NUCLEAR REGULATORY COMMISSION  
[Docket No. 50-358]

CINCINNATI GAS AND ELECTRIC COMPANY  
(William H. Zimmer Nuclear Power Station)

Issuance of Director's Decision Under 10 CFR 2.206

### NRC RESPONSE TO COMMENTS ON CG&E'S COURSE OF ACTION

FIGURE 2 CGGE PROPOSED ZIMMER PROJECT ORGANIZATIONAL STRUCTURE

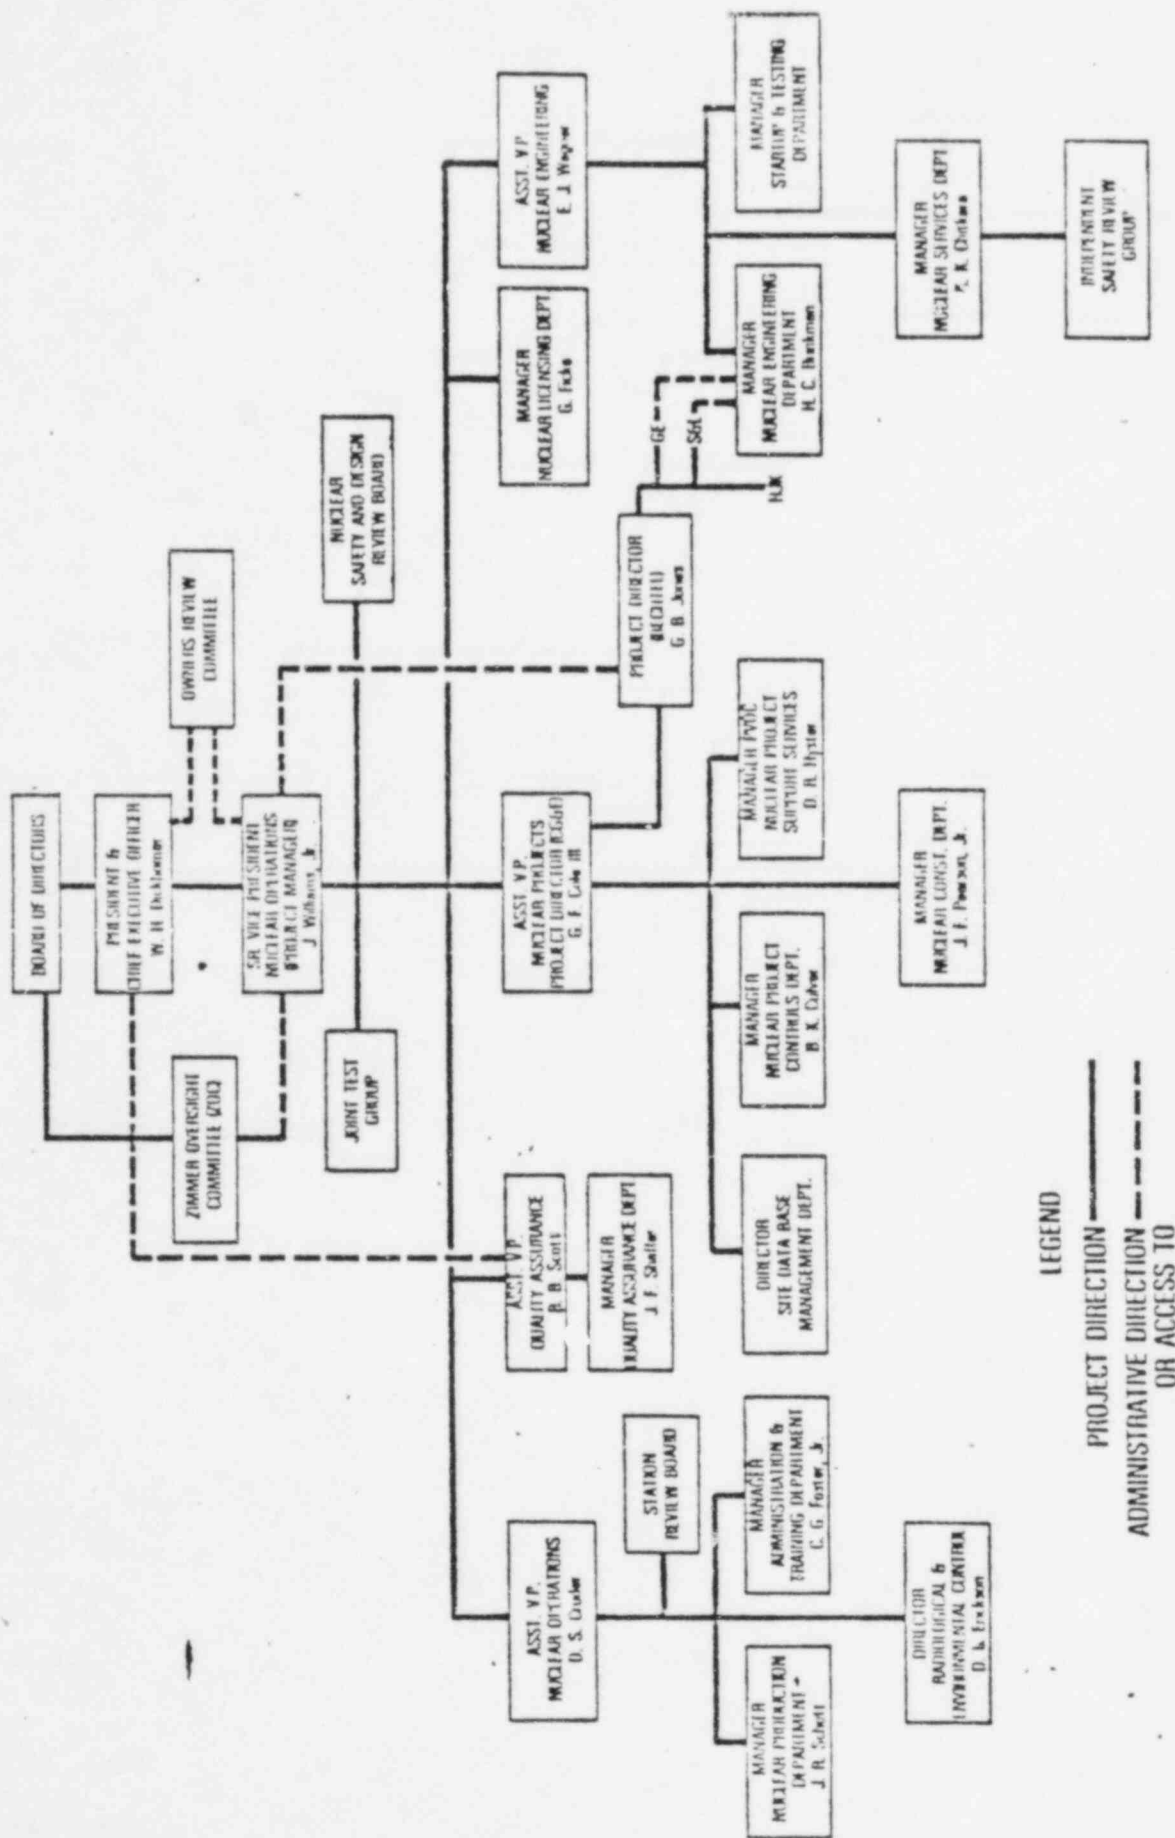
The proposed organizational structure described in the COA is given in Figure 2. Bechtel will be the "experienced outside organization" that will conduct both quality assurance and construction project management and will assume responsibilities of construction. The Project Director (Bechtel) will report to the Assistant Vice President, Nuclear Projects (CG&E). The Project Director (Bechtel) will have direct access to the CG&E Senior Vice President, Nuclear Operations, if needed. The Project Director (Bechtel) will be responsible for assessing the adequacy and implementing of the QA programs of the contractors they manage.
